PRELIMINARY/FINAL DRAINAGE REPORT

JUDGE ORR ROAD RV PARK & STORAGE DEVELOPMENT

**ADP Project No.160301
July 25, 2018**

PCD Project #PPR-16-040

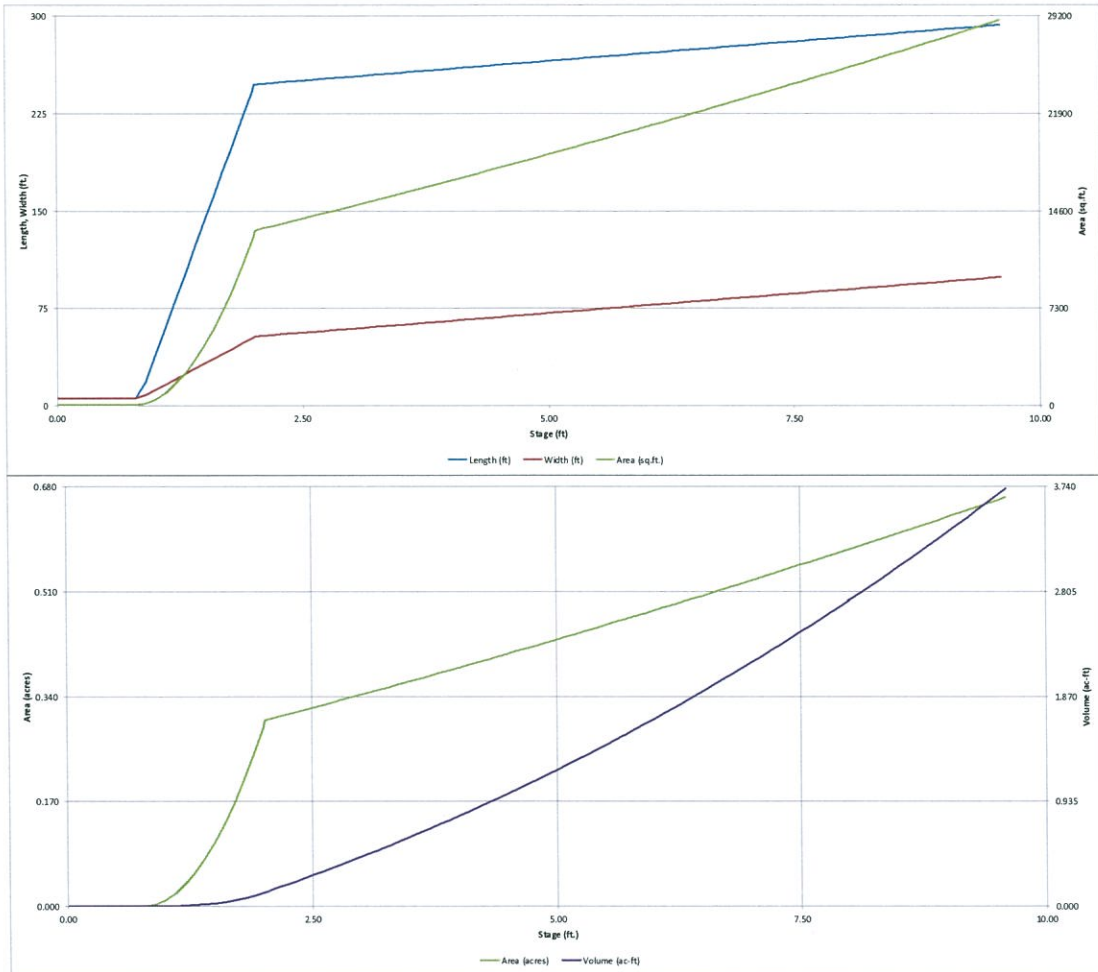
Revise the Pond 2 stage-storage based on the constructed pond shape shown on the GEC plan and not the computer generated values. Input the values in the "optional override stage/area".

The auto-generate for Pond 1 is okay since it was mainly for modeling the pond in a series based on an assumed condition for Pond 1.

However, add a statement that with development of pond 1 that drainage report will have to provide the same pond in a series analysis to verify release rates still meet Senate Bill 15-212.

DETENTION BASIN STAGE-STORAGE TABLE BUILDER

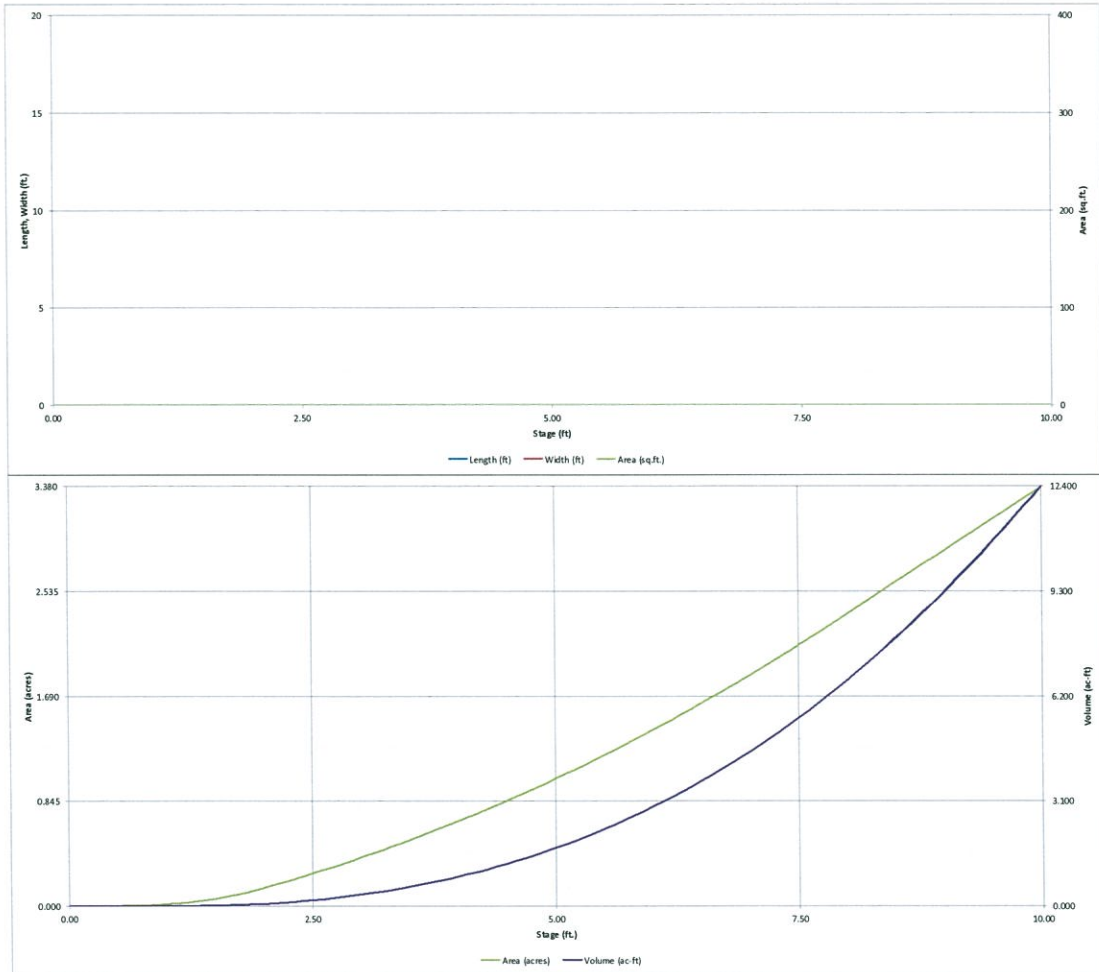
Update title. Staff assumes this is Pond 2 design (w/ Pond 1 & 2 in a series).

Revise. Drain time is not in compliance with senate bill 15-212 (must be less than or equal to 72 hours).

PROJECT: Judge Ave. Rd. Dr. Pk. Falls
 Culvert At DP 1

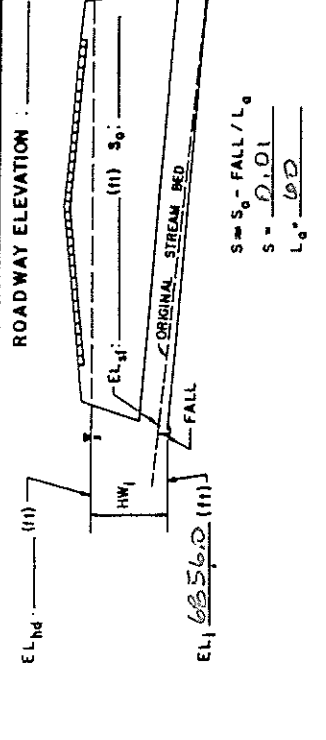
Provide the analysis for overtopping on a Major Storm (per drainage map Q=59.6cfs). Must meet the criteria per Table 6-1 & Table 6-4: Depth of flow shall not exceed 6 inches at the edge of the road shoulder. Similar comment for the east culvert.

FOR CONTINUATION OF BASIN
SEE OFF-SITE MAP FOR O-1 IN
APPENDIX B

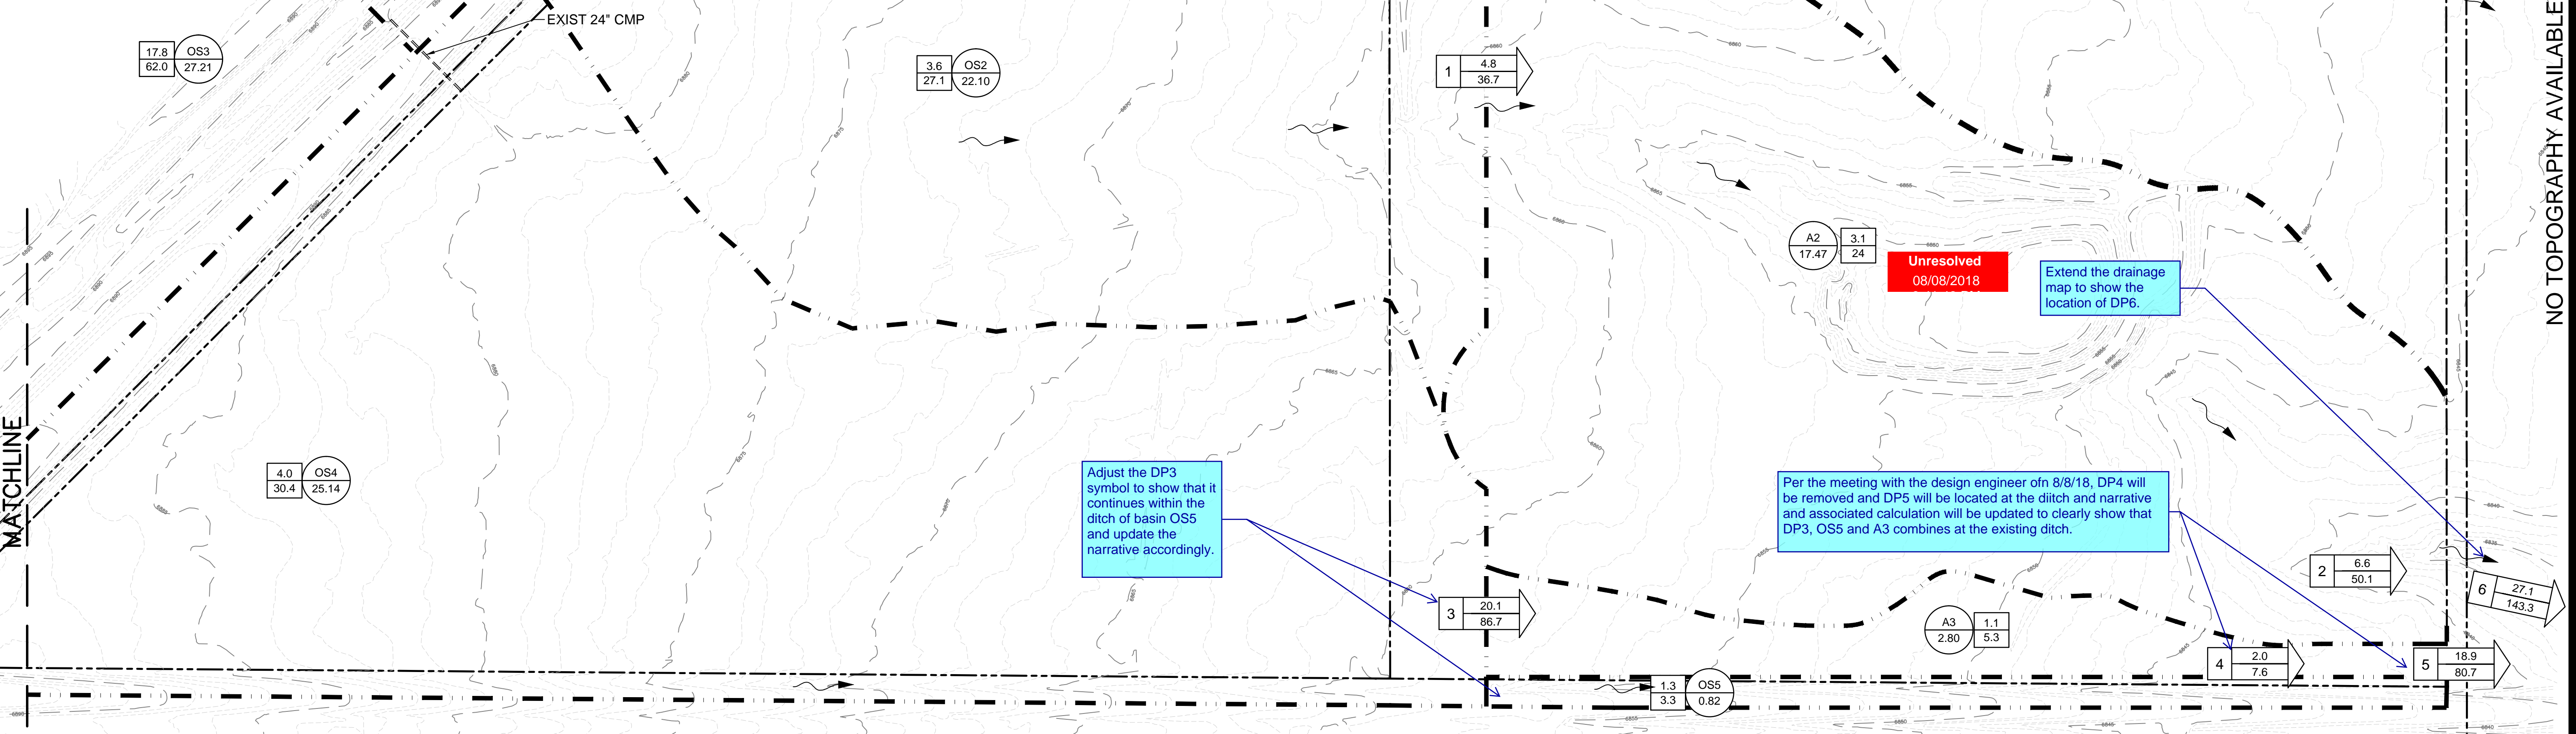
1. DP4 should be (DP3 + A3). DP3 flows go through Basin A3. Update the narrative and calculations accordingly.
2. Then DP5 is (DP4 + OS5).
3. DP6 is DP2 + DP5 + A1.

Extend the drainage map to show the location of DP6.

Adjust the DP3 symbol to show that it continues within the ditch of basin OS5 and update the narrative accordingly.

Per the meeting with the design engineer on 8/8/18, DP4 will be removed and DP5 will be located at the ditch and narrative and associated calculation will be updated to clearly show that DP3, OS5 and A3 combines at the existing ditch.

JUDGE ORR ROAD RV PARK & STORAGE
 COLORADO SPRINGS, COLORADO
 DRAINAGE - DEV OVERALL CONDITIONS

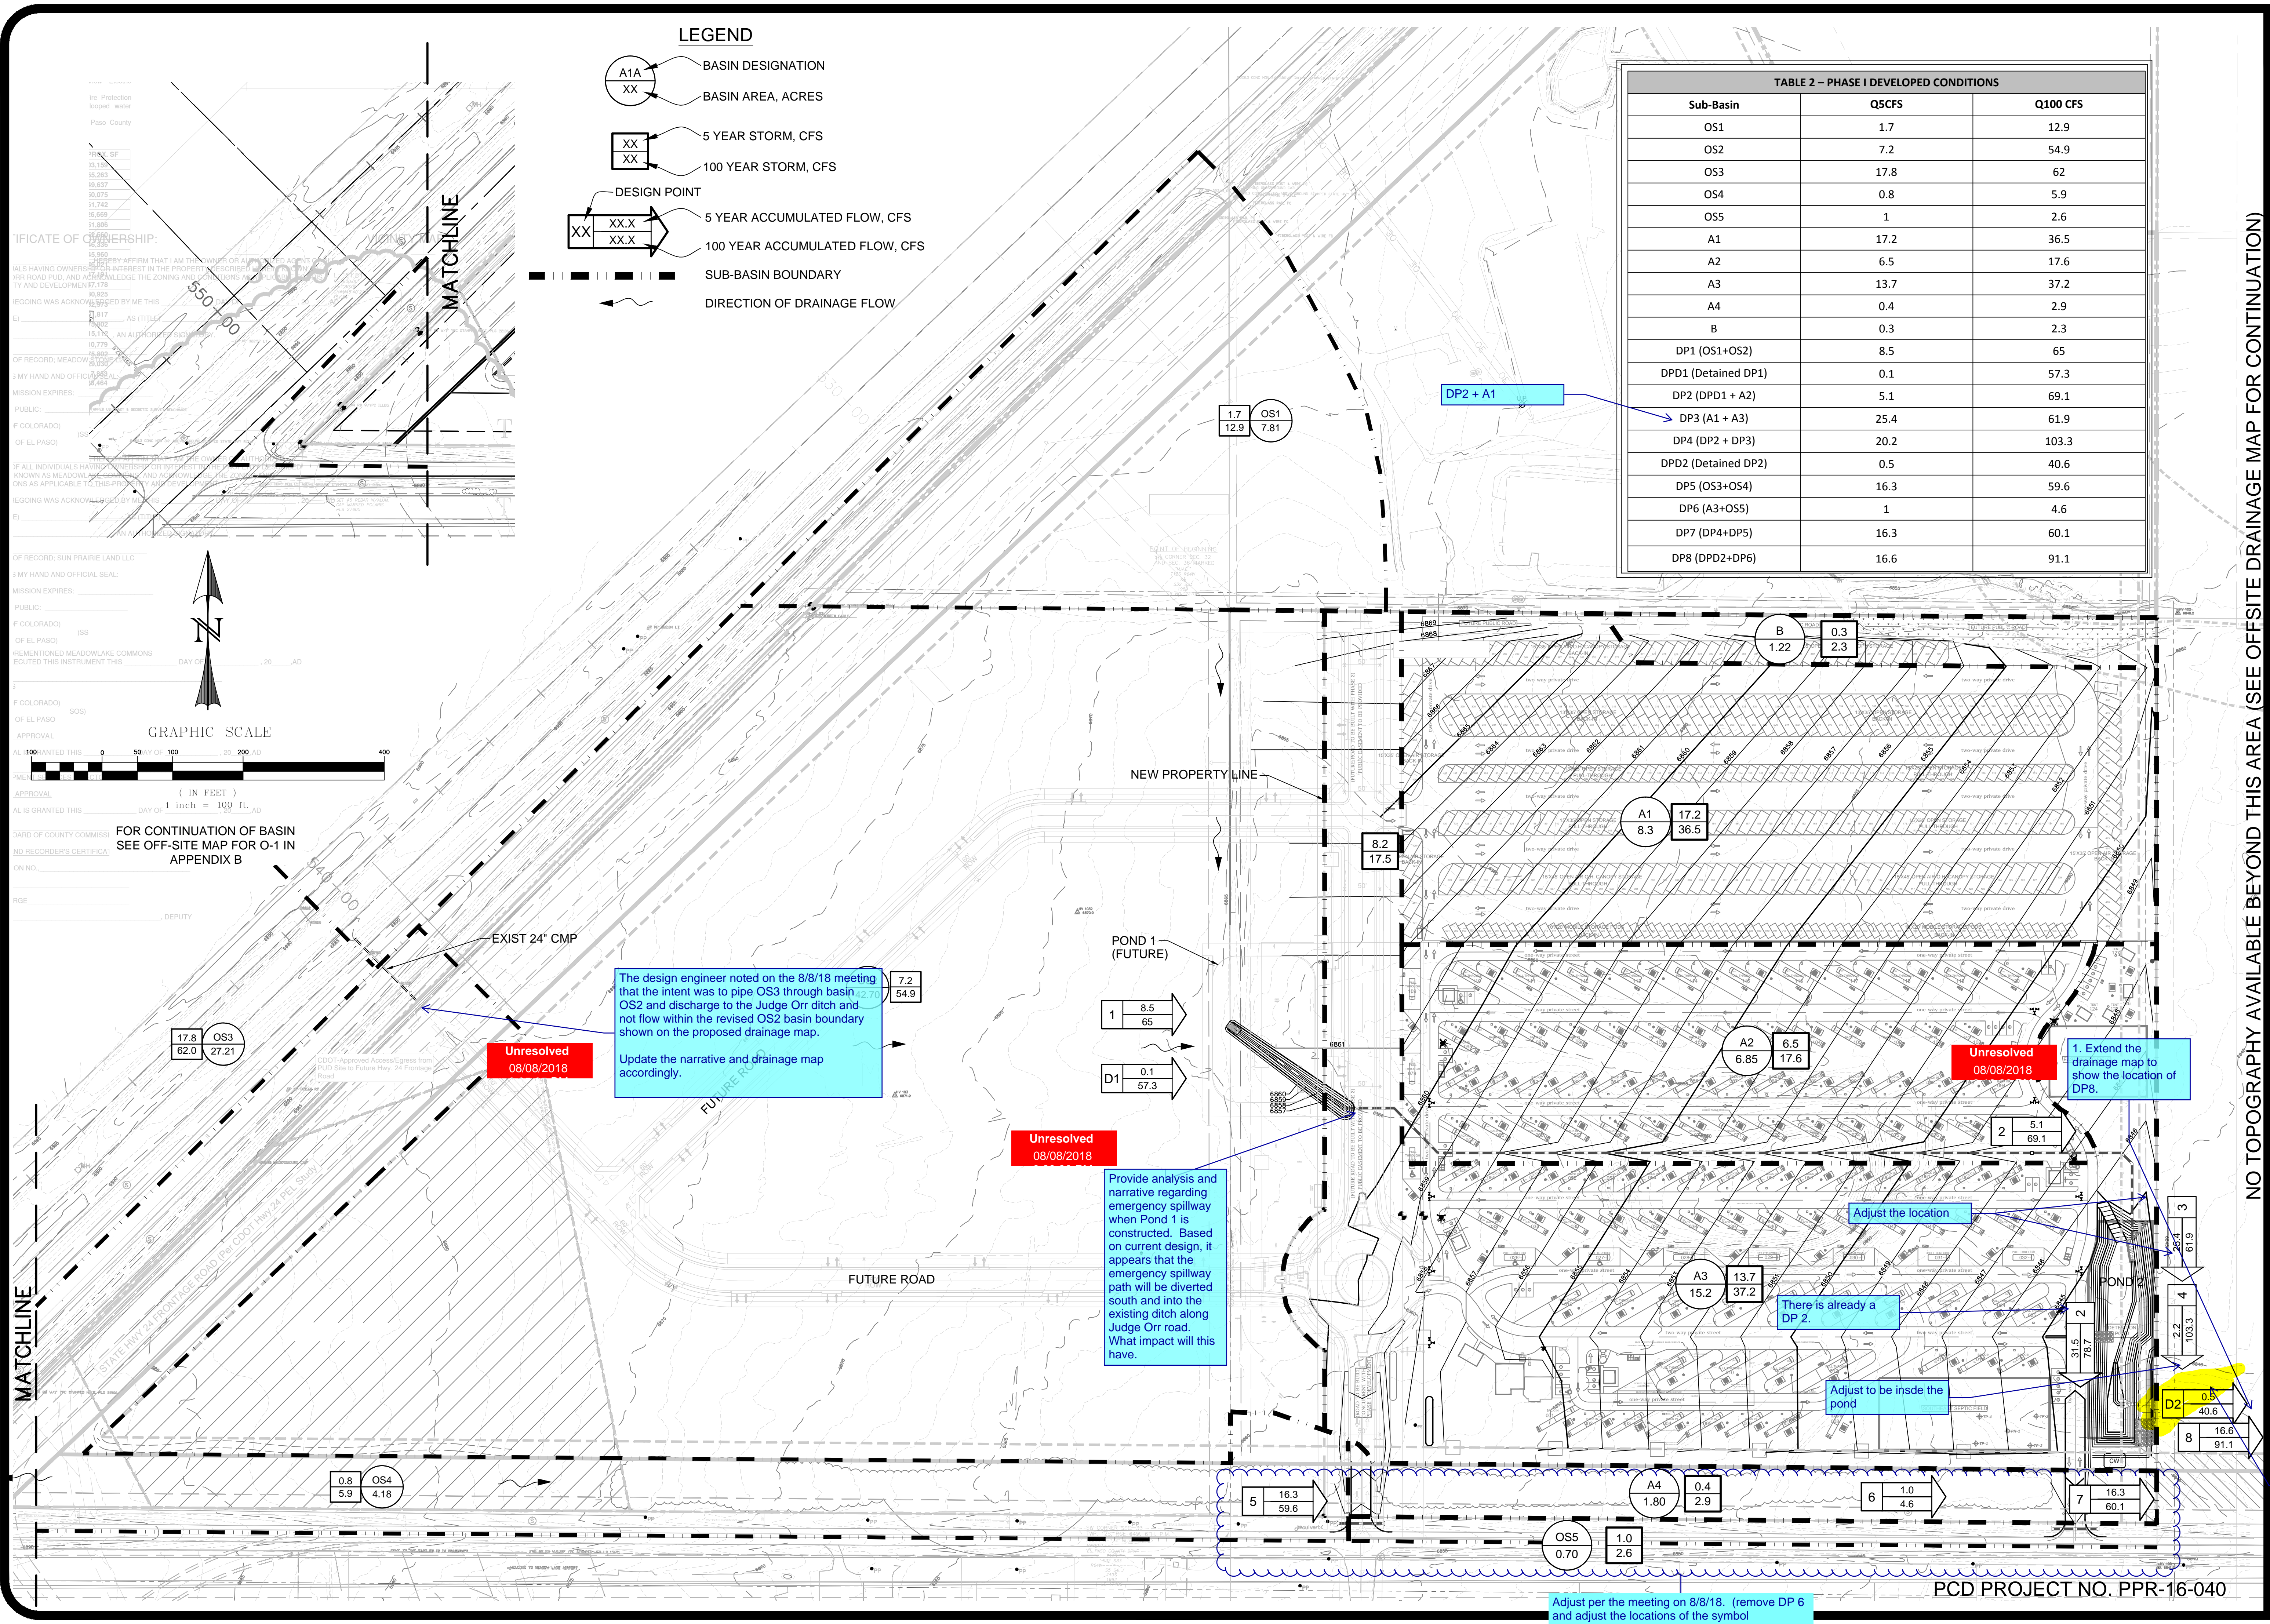
The design engineer noted on the 8/8/18 meeting that the intent was to pipe OS3 through basin OS2 and discharge to the Judge Orr ditch and not flow within the revised OS2 basin boundary shown on the proposed drainage map.

Provide analysis and narrative regarding emergency spillway when Pond 1 is constructed. Based on current design, it appears that the emergency spillway path will be diverted south and into the existing ditch along Judge Orr road. What impact will this have.

1. Extend the drainage map to show the location of DP8.

Adjust per the meeting on 8/8/18. (remove DP 6 and adjust the locations of the symbol
